MEMORANDUM

P910023/S295
P030054/S223
Software Model MN5000 v6.1 for use on Merlin.net System and Model EX2000 v6.1 for use on Merlin@home devices
St. Jude Medical

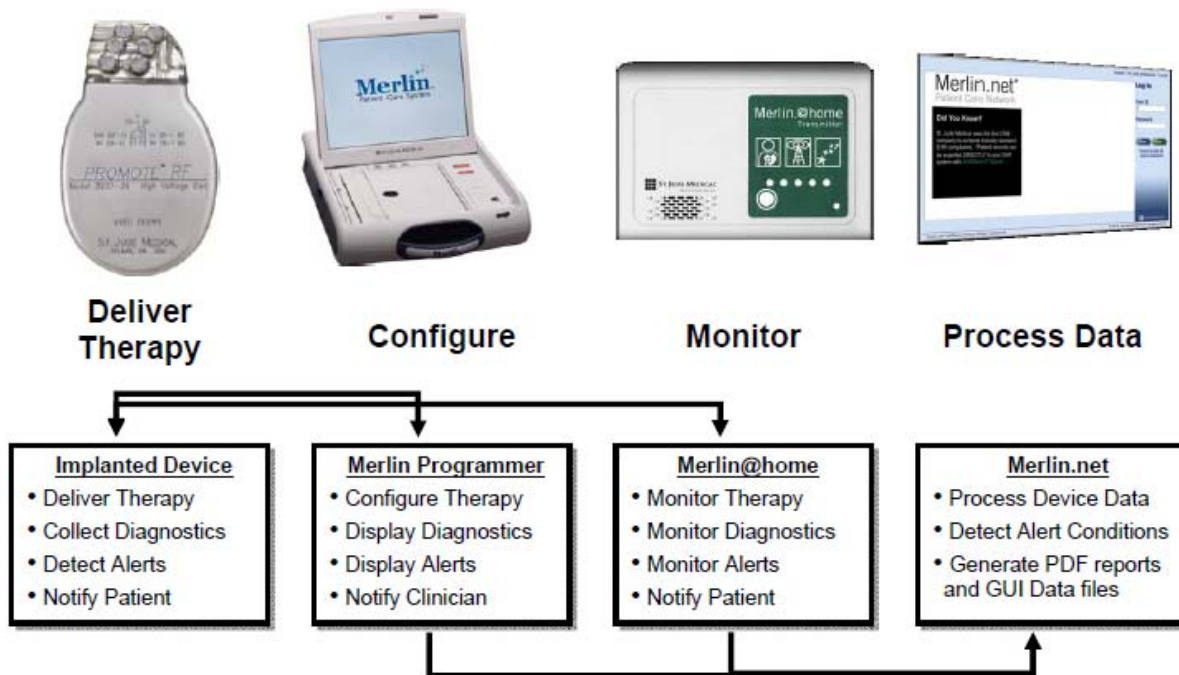
The system is depicted in the figure below. The software modifications described in this supplement affect the Merlin@home and the Merlin.net products only. There are no changes to the Merlin programmer or the implanted device.
